TOWN OF RAYMOND  
Planning Board Agenda

**June 6, 2024**

Subject: **Gemini Valve Site Plan Application**  
**Tax Map 28; Lot 4-3**  
**2 Otter Court**  
**Raymond, New Hampshire 03077**  
KNA Project No. 22-0110-2

Our office is in receipt of your comments, dated March 22, 2024. Based on the comments, we have made the required modifications and attached revisions for final review. A response to each comment has been provided below.

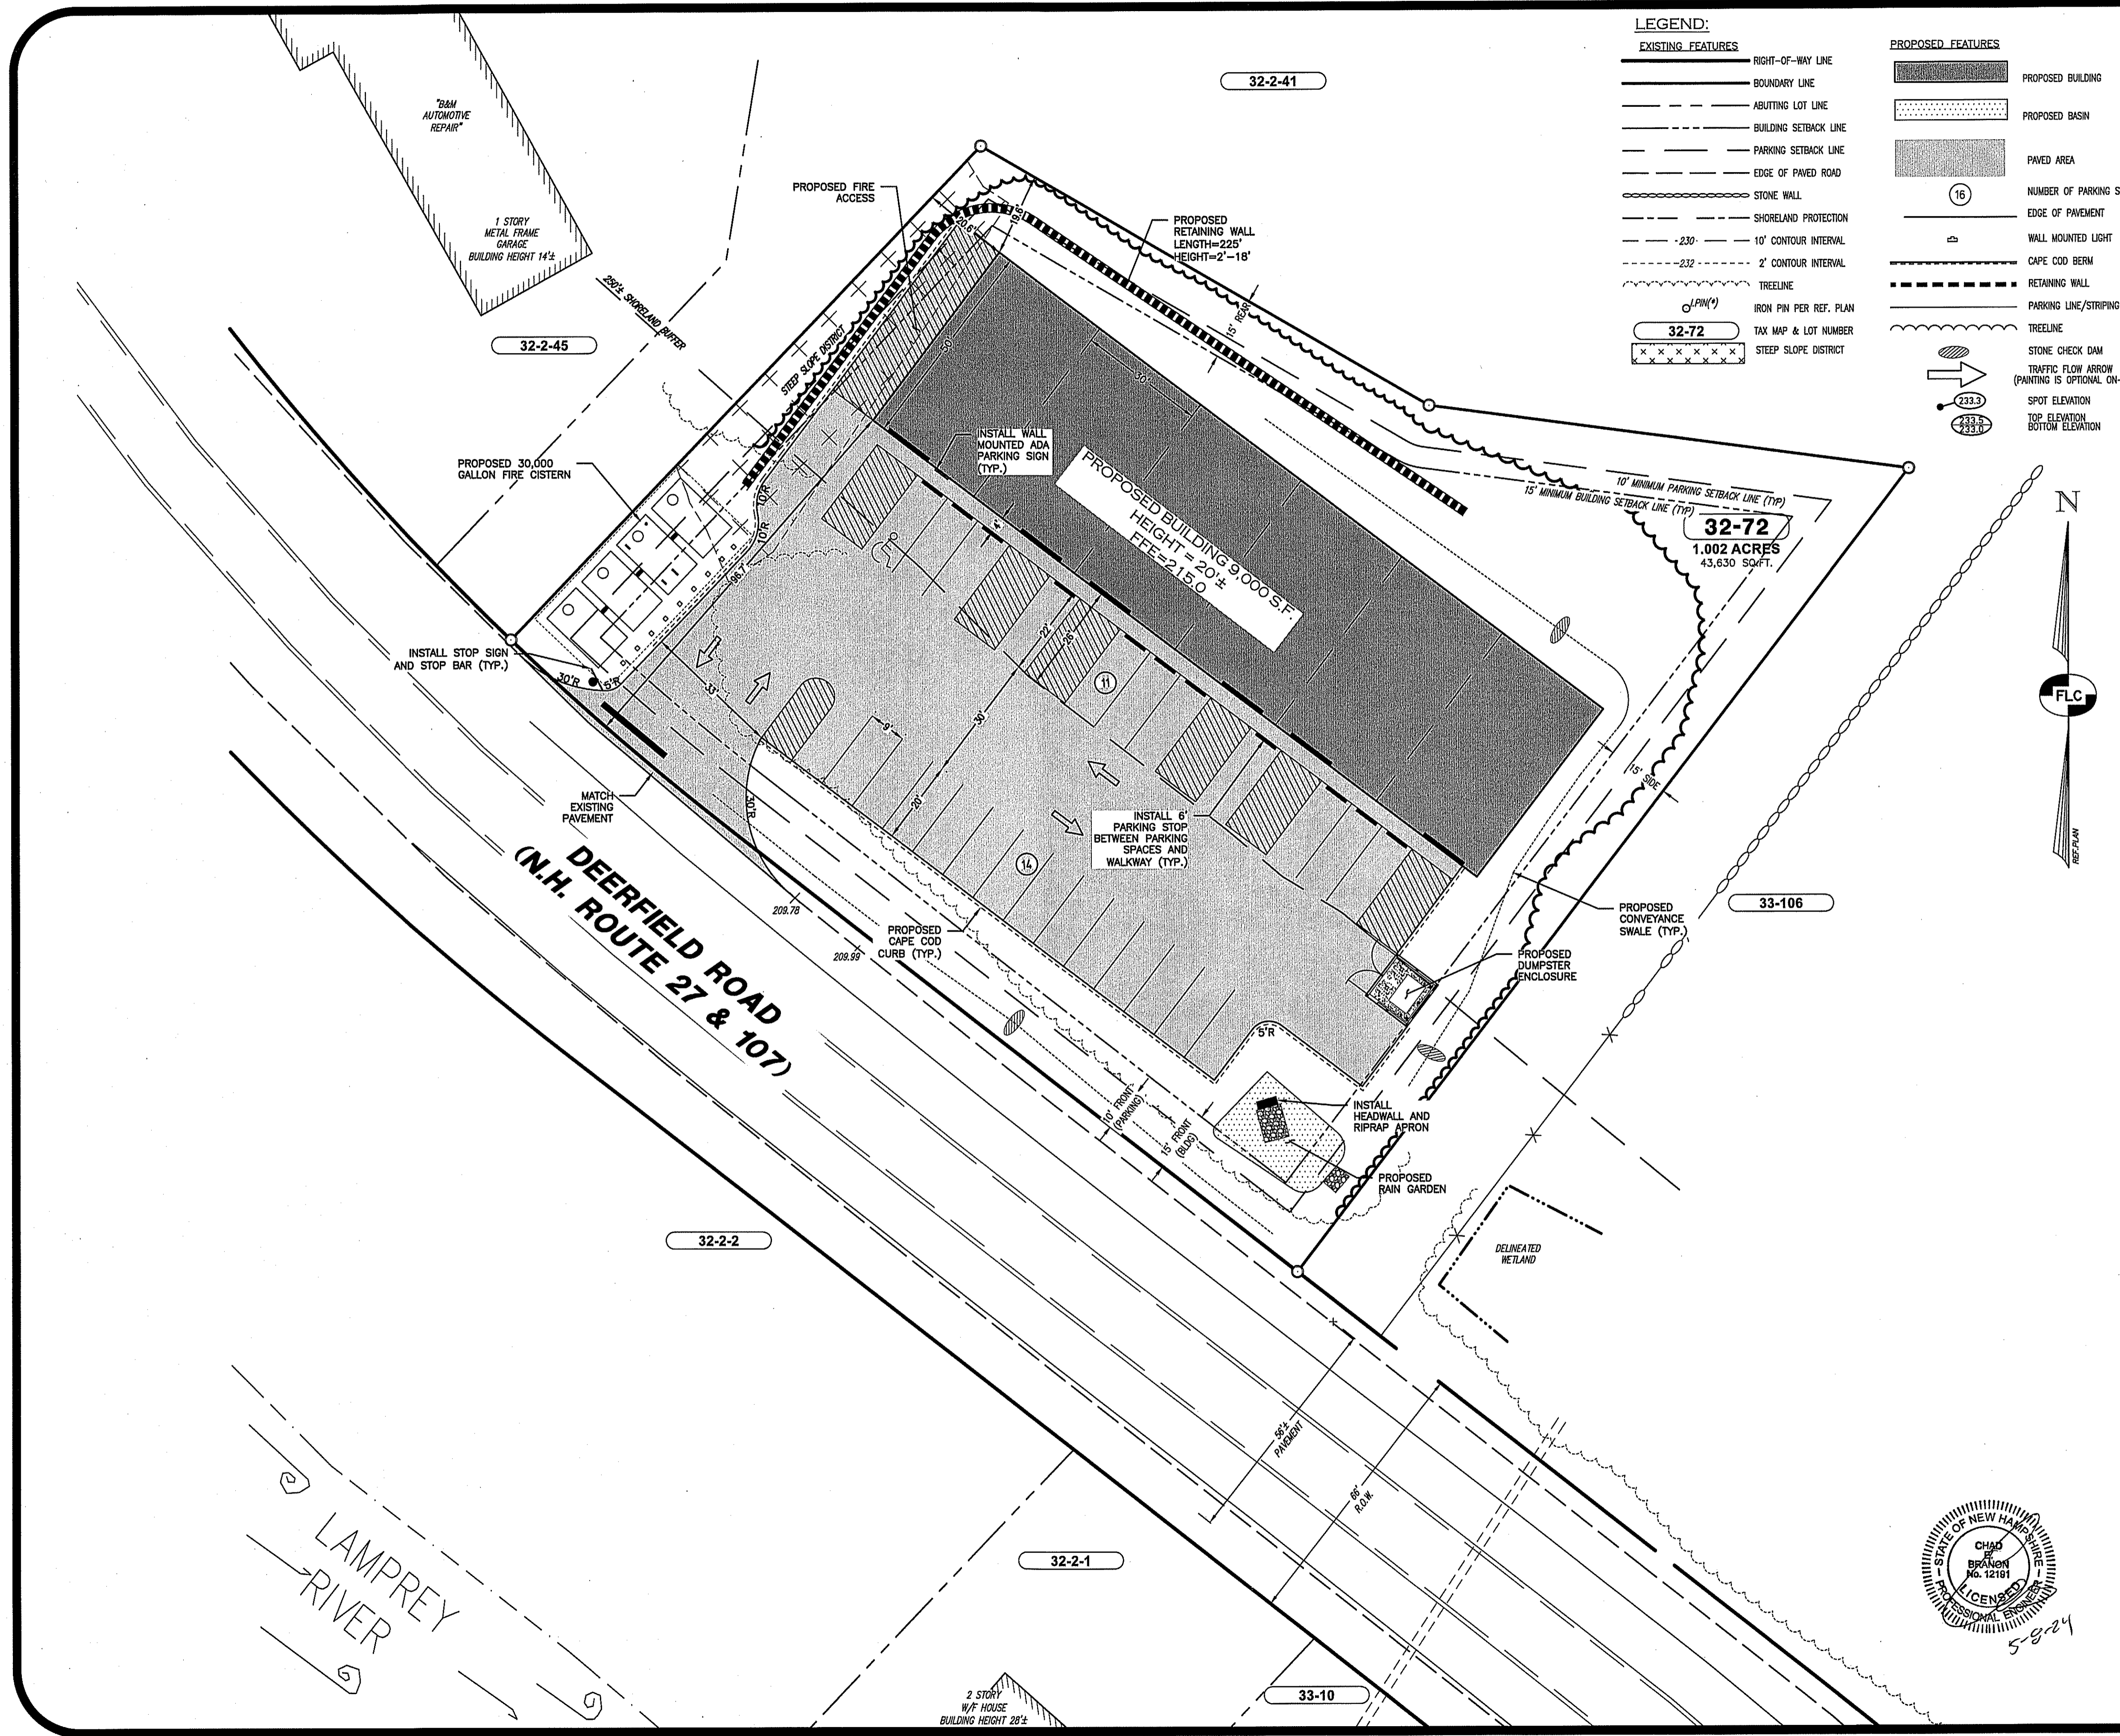
1. In the sheet index, the title for page 11, sheet DT-5, does not match the title on sheet DT-5 and should read "Construction Details".

*The sheet index has been updated to match title on sheet DT-5.*
